**RE: CHANGE OF DEVELOPMENT APPLICATION AND
RESPONSE TO INFORMATION REQUEST – MATERIAL
CHANGE OF USE FOR MULTIPLE DWELLINGS AND
RECONFIGURING A LOT (1 INTO 5) ON LAND LOCATED
AT 11-15 DICKSON STREET, CRAIGLIE (LOT 404
C2241)**

COUNCIL REF: CA3131/2019

Notice of Change of Application

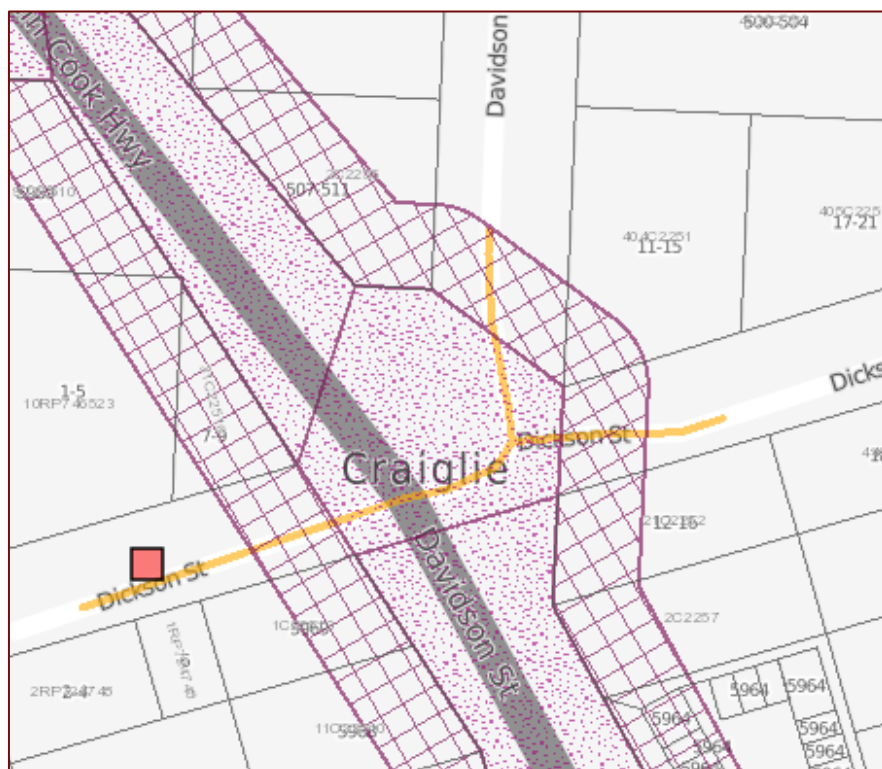
Provided below is a plan of the location of Councils existing water and sewer infrastructure received from the Councils Water Reticulation department. The blue lines represent the water infrastructure and the red line sewer.

To provide a water service to the proposed allotments its it intended to extend the water main along the northern boundary of Dickson Street, within the road reserve and provide house connection branches at appropriate intervals.

To provide a sewer connection to each of the proposed allotments it is intended to extend the sewer main adjacent the common boundary of 11-15 Dickson Street and 17-21 Dickson Street and within 17-21 Dickson Street, which is in the ownership of the applicant. The sewer line would then be extended along the rear boundary of proposed lots 11-13 with appropriate construction to provide for buildings within proximity of sewers. The detailed design of the infrastructure layout is required to be undertaken at the time of application for operational works, which will require approval prior to the endorsement if a plan of survey of subdivision.

LOT PLAN

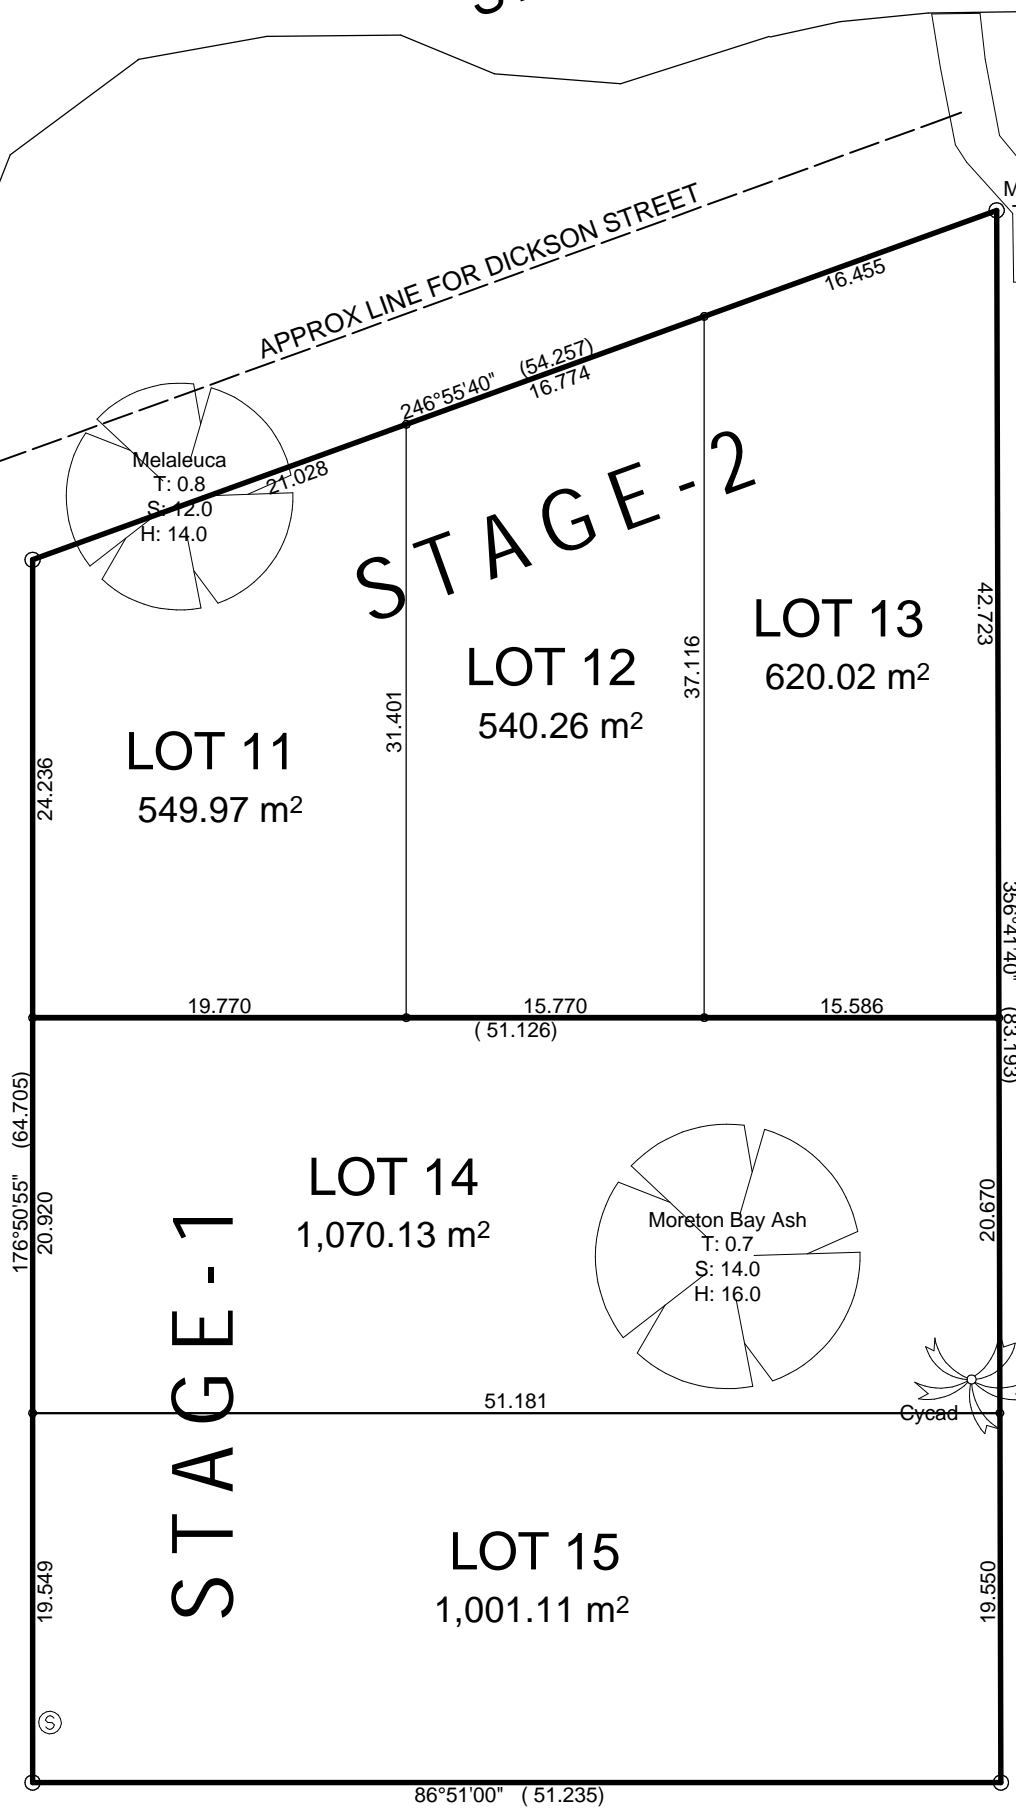
Please find attached an amended plan of Reconfiguring a Lot and an amended site plan in respect of the proposed development. The plan of reconfiguration has been amended to increase the size of proposed lot 15 from 610.59m² to 1,001.11m² and to indicate the proposed staging of the development.

The effect of the amendment is that proposed lot 14 and proposed lot 15 each have a minimum lot size of 1,000m² and are compliant with the requirements of the Acceptable
